Isle of Anglesey County Council		
Report to:	The Executive	
Date:	29 th February 2024	
Subject:	Improving the reliability and the resilience across the Menai Straits	
Portfolio Holder(s):	Cllr. Llinos Medi (Economic Development) & Cllr. Dafydd Rhys Thomas (Highways, Waste and Property)	
Head of Service / Director:	Christian Branch Head of Service – Regulation & Economic Development Huw Percy Head of Service – Highways, Waste and Property	
Report Author: Tel: E-mail:	Tudur H. Jones 2146 <u>tudurjones@ynysmon.llyw.cymru</u>	
Local Members:	Relevant to all Elected Members

Annex A - Response to the North Wales Transport Commission's Report: 'Improving the Resilience of Connections Across the Menai Strait'

Response to the North Wales Transport Commission's Report: 'Improving the Resilience of Connections Across the Menai Strait'

January 2024

Figure 4.1: 5km catchment

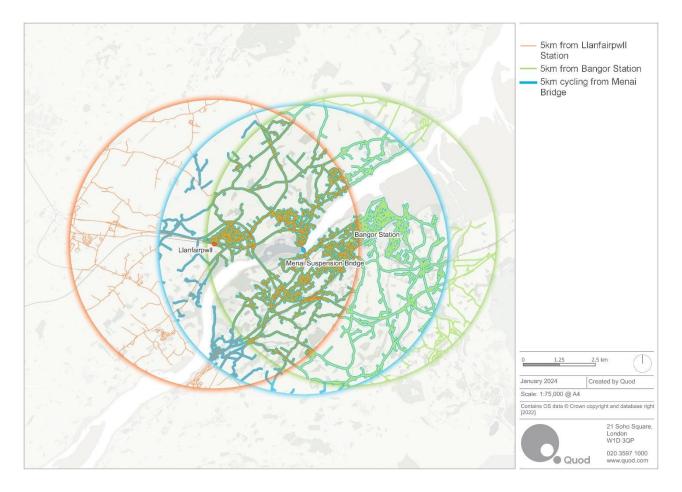
- 4.4 There is a limited population within walking and cycling distance of the bridges and limited routes where a mode shift could occur.
- 4.5 In 2019, there were only 24 cycle trips recorded across the Britannia Bridge. While we acknowledge that some of this is due to safety concerns that could be improved by the recommendations in the report this is a very low base on which to build.

- 4.7 The report considers 5 kilometres as a reasonable cycle distance and identifies Bangor, Menai Bridge, LlanfairPG, Ysbyty Gwynedd and Park Menai as key employment destinations. The map below shows a 5km catchment from Bangor, LlanfairPG and Menai Bridge. This shows that there are relatively few trips where cycling would be possible, this includes:

- Bangor (including Ysbyty Gwynedd) to Menai Bridge and vice versa
 - LlanfairPG to Bangor and vice versa
